Department of Public Works  
Engineering Division

CITY OF BERKELEY  
STRAWBERRY CREEK CULVERT MAINTENANCE PROJECT – PHASE 1  
SPECIFICATION NO. 25-11689-C  
**ADDENDUM NO. 2**

**STANDARD DETAIL  
CATCH BASIN  
WITH CURB INLET**

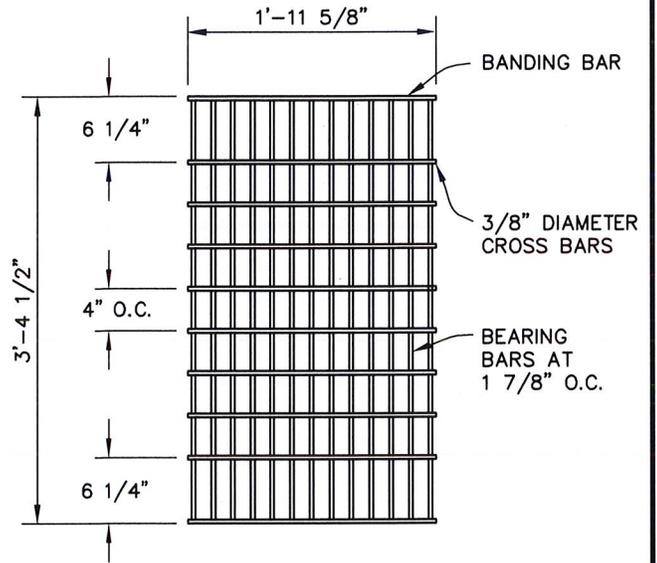
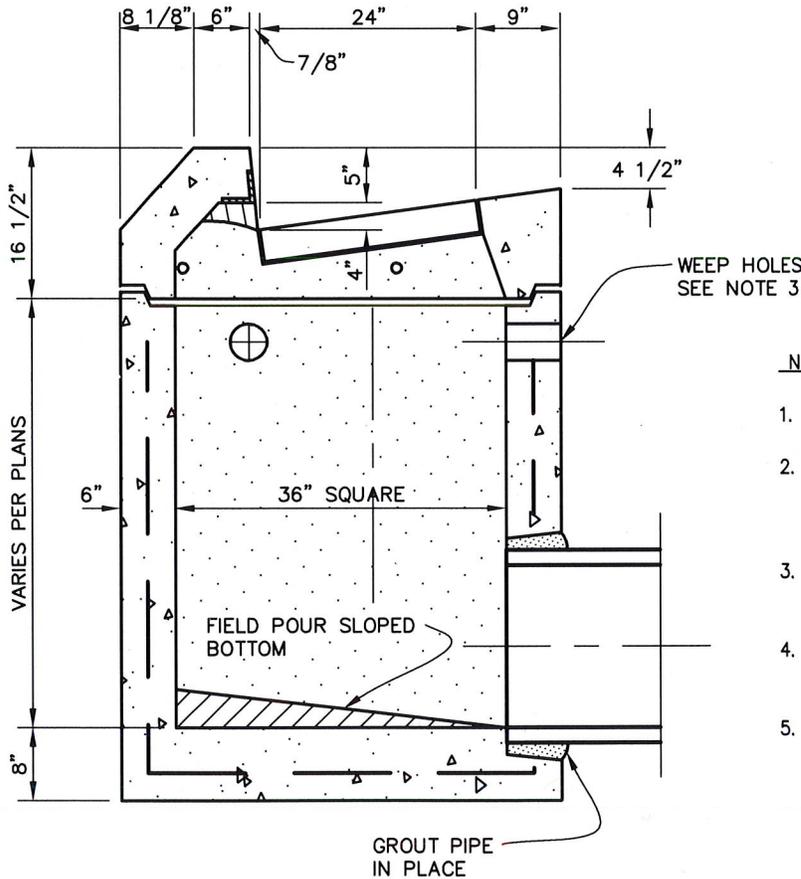
3. **Question:** Drainage inlets will likely have to be removed to create enough access for workers and equipment. Does the City have a standard DI detail for replacement?

**Answer:** *The contract plans and specifications describe available access points for the installation of the geopolymer lining. If Contractor seeks to remove an existing catch basin top to facilitate contract work, catch basin reconstruction shall be per City Standard Plan 6166 (attached).*

*Modification, removal, and replacement of existing infrastructure, where not shown on the plans, shall be at the Contractor's expense and shall require Engineer approval.*
